Hi-Fi Products
Service Bulletin

Model: CDP-68/307ESD/750/950

No. 32

Subject: No Chucking Operation

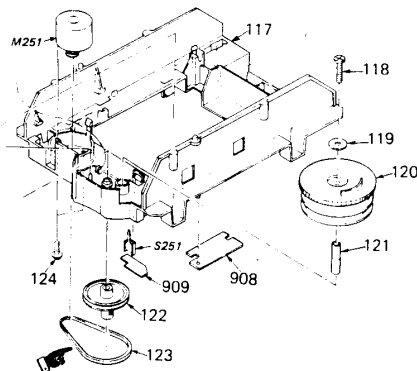
During the loading cycle, the disc will not be completely chucked. The optical section may swing upward only partially or perhaps not at all.

Cause: This is caused by the drive belt slipping.

Solution: Replace the former drive belt with a newer version drive belt. The part number is listed below:

Ref. No.	Description	Part Number	
		Former	New
123	Belt	4-917-522-01	4-917-522-02
